A585 Windy Harbour to Skippool Improvement Scheme

TR010035

7.11 Environmental Statement Changes and Corrections Document

Environmental Statement Changes and Corrections Document

Status	DEADLINE 2 SUBMISSION	Revision	1
Scale	1:2500 A3	Date	MAY 2019
Drawn By	J.NORMAN		
Checked By	K.BURROWS		
Approved By	N.HENDERSON		
PINS No.	TR010035	FIGURE	11.4
Drawing number	HE548643-ARC-EGN-SZ_ZZ_000-DR-LE-30

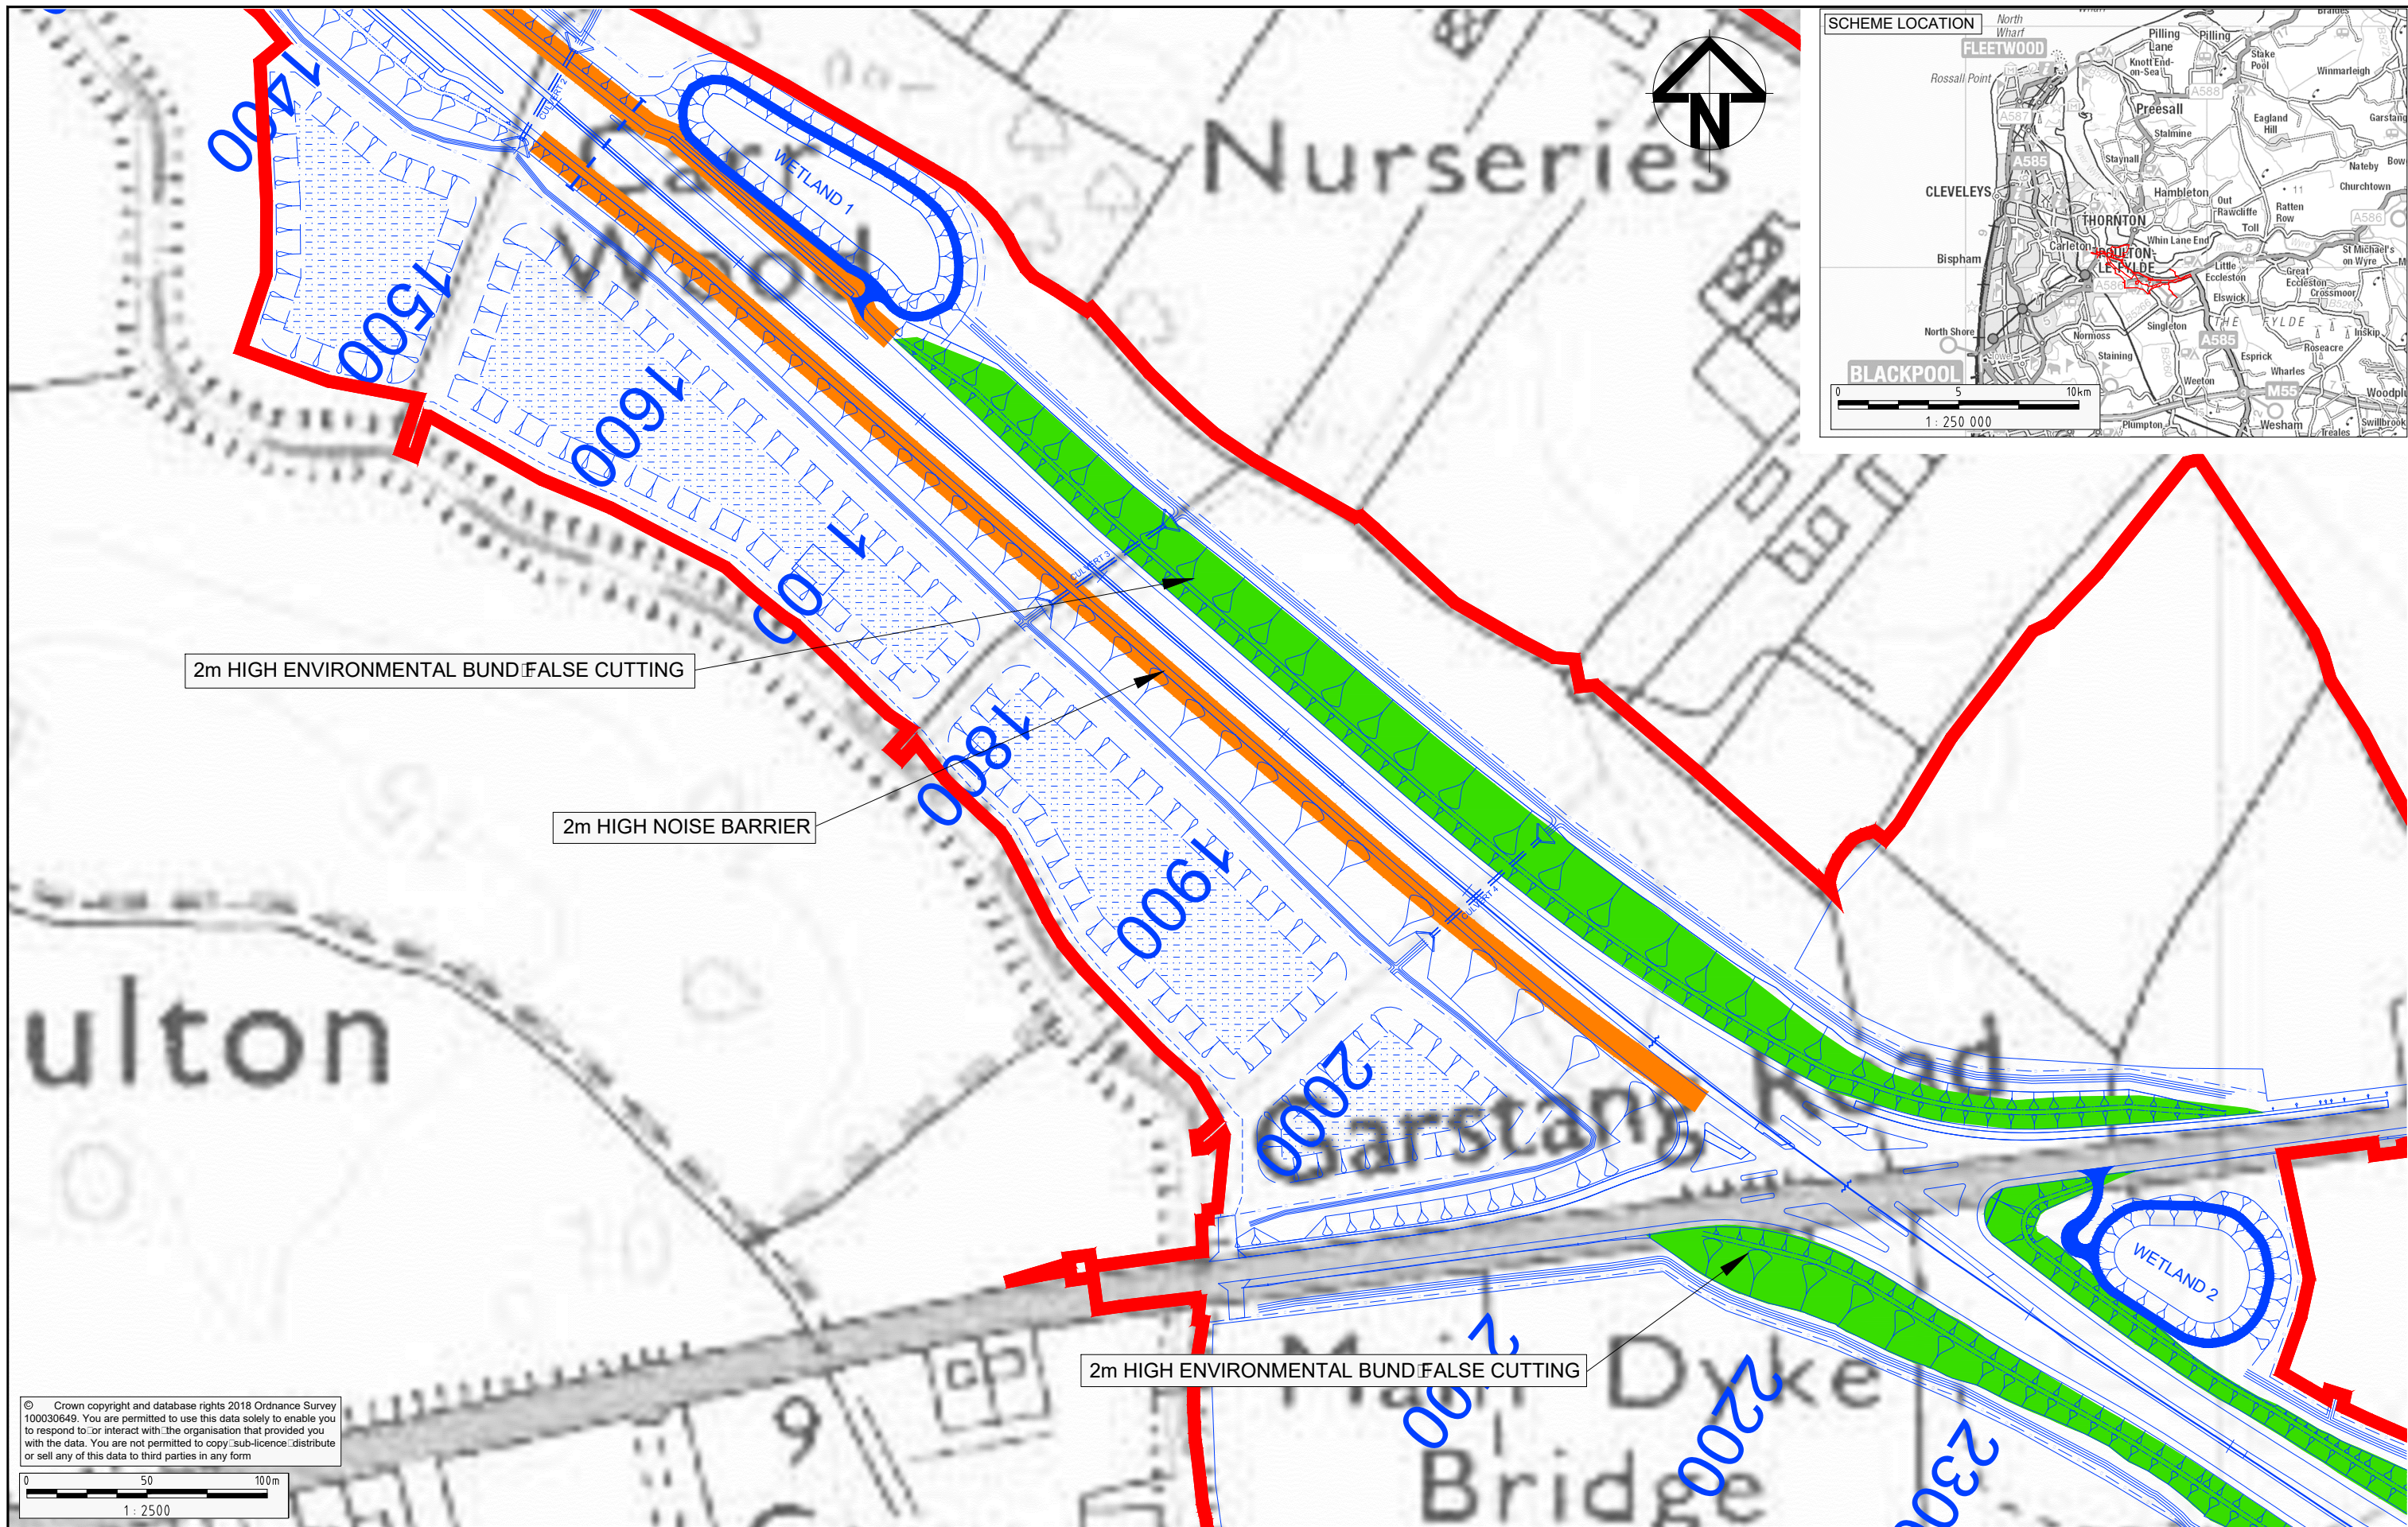
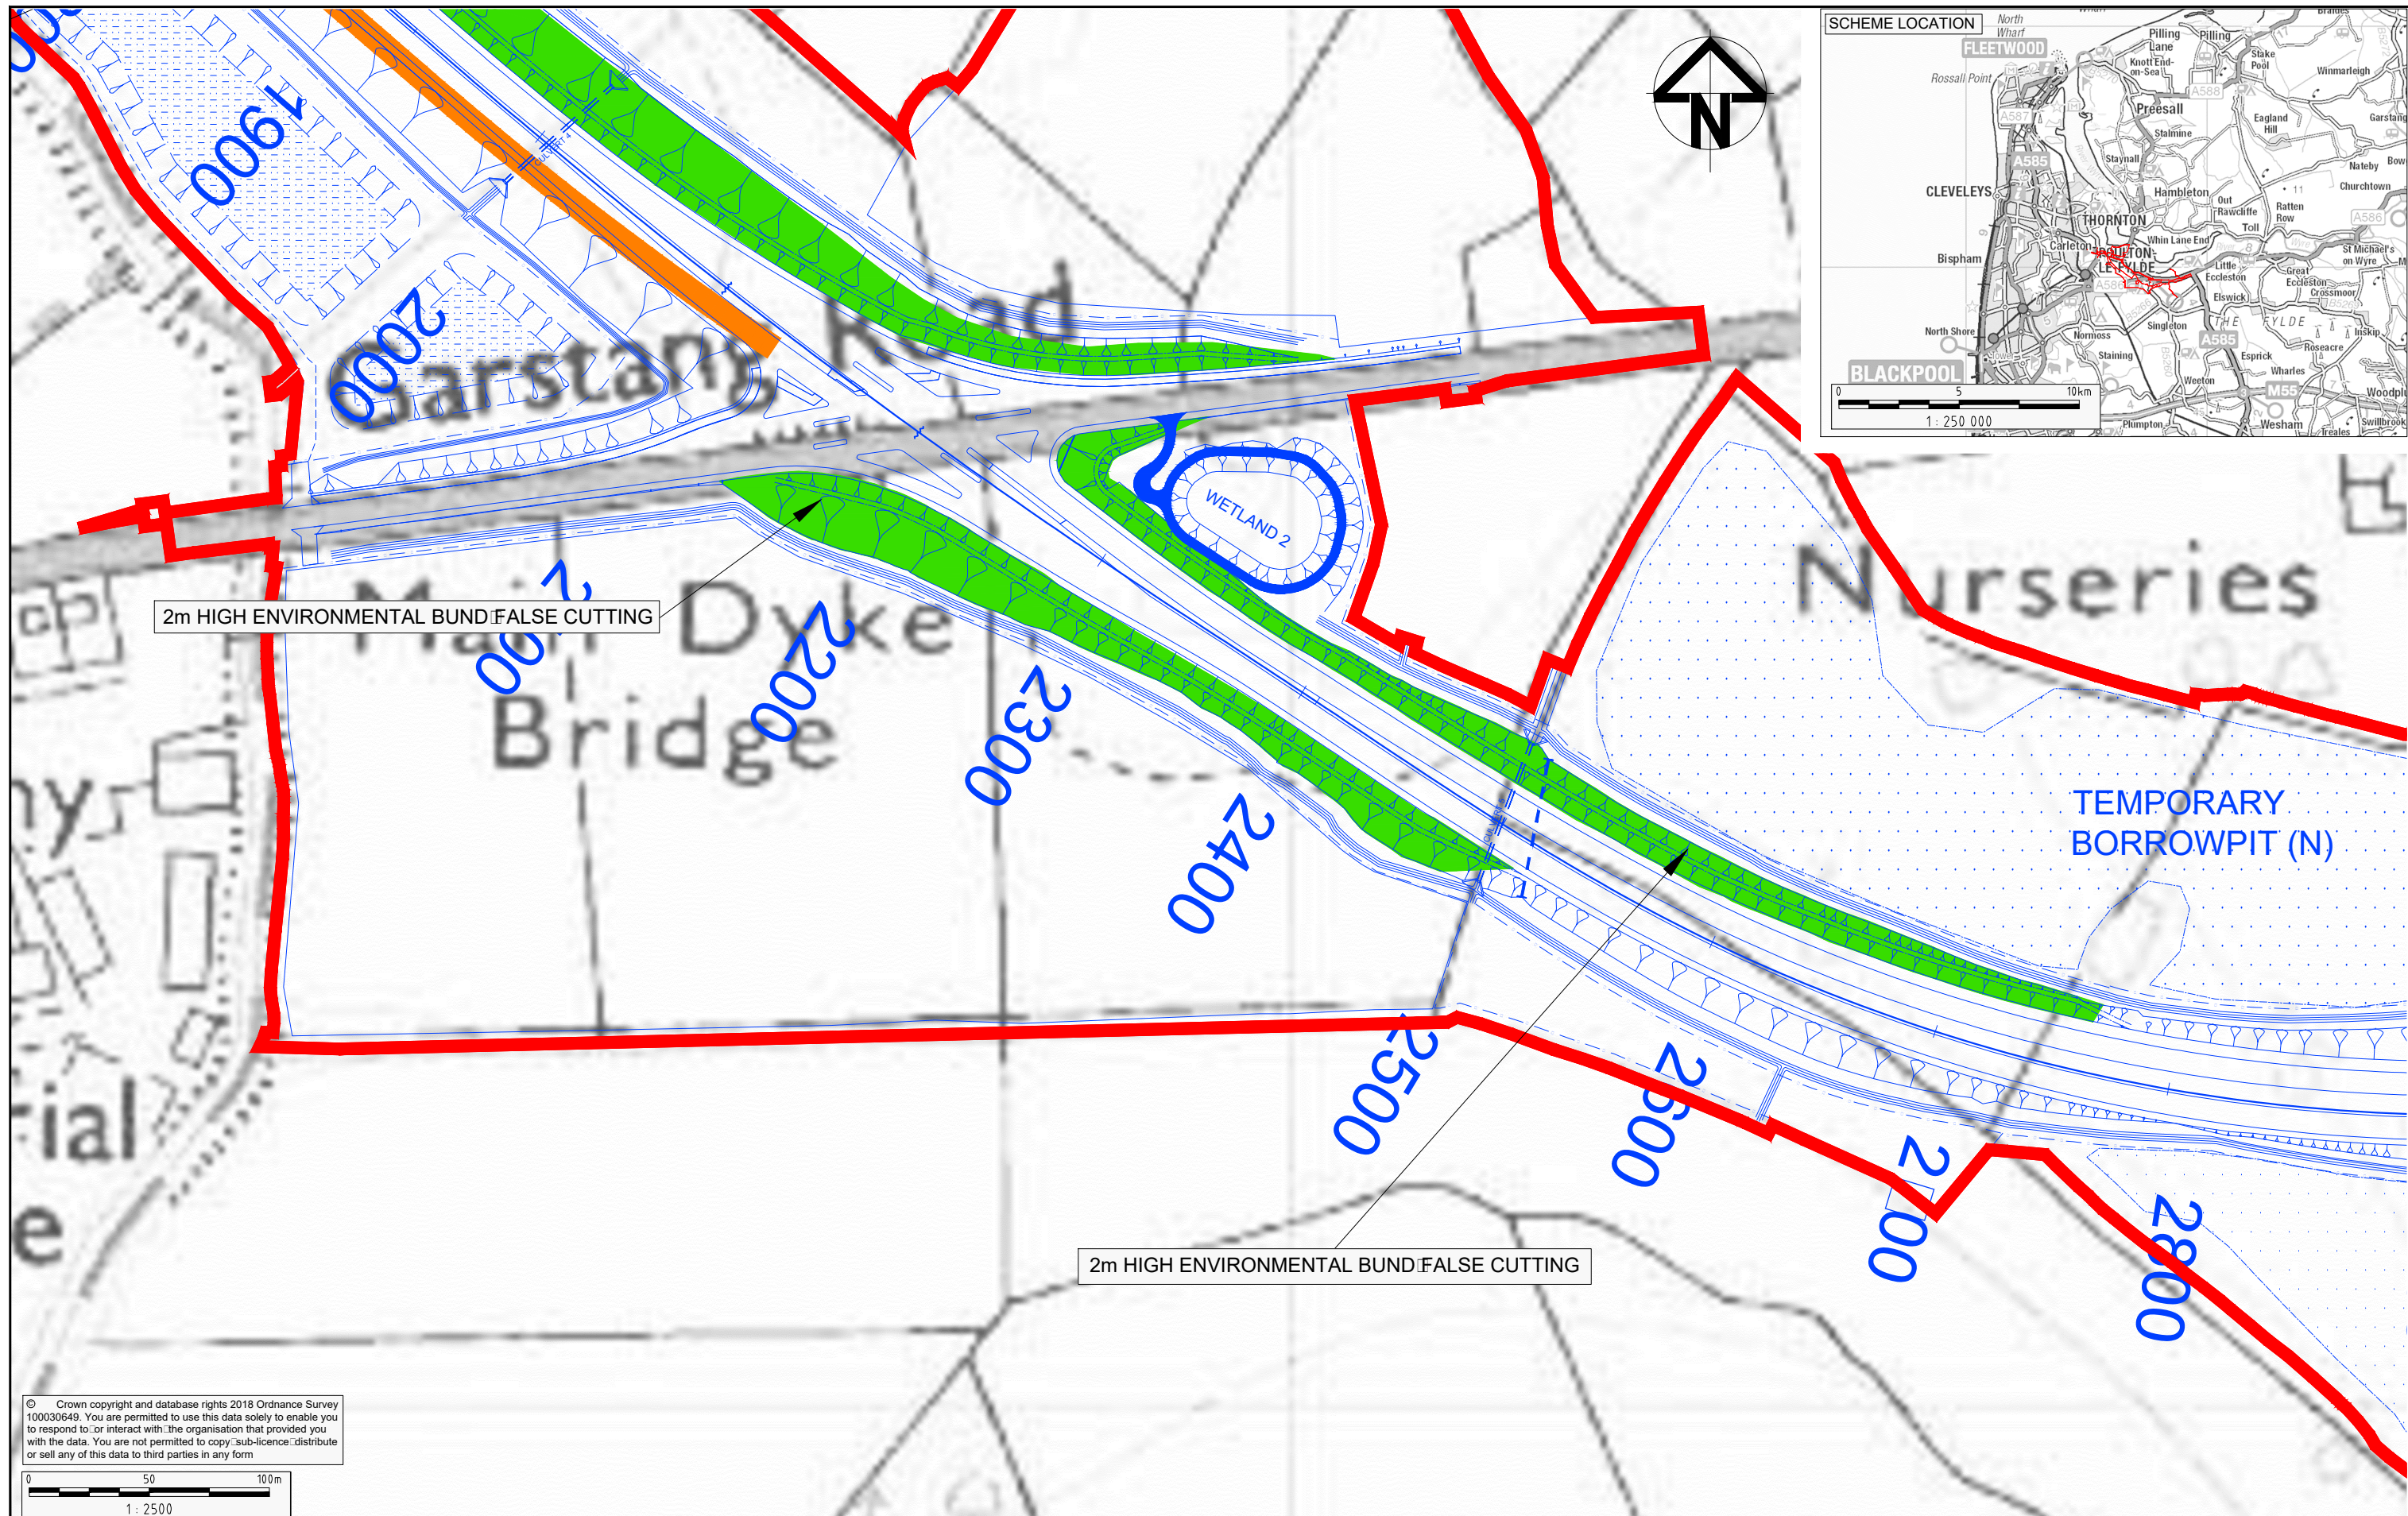
Document Reference Number	Document Name	Amendment Required	Reason
			TR010035/APP/7.10).
6.11	ES Chapter 11: Noise and Vibration	Update to Figure 11.4: Noise and Vibration – Noise Mitigation within the Study Area presented at Appendix D to show heights and locations of earth mounds and acoustic fencing at a larger scale.	Requested by the Inspector within the first round of written questions (document reference TR010035/APP/7.10).
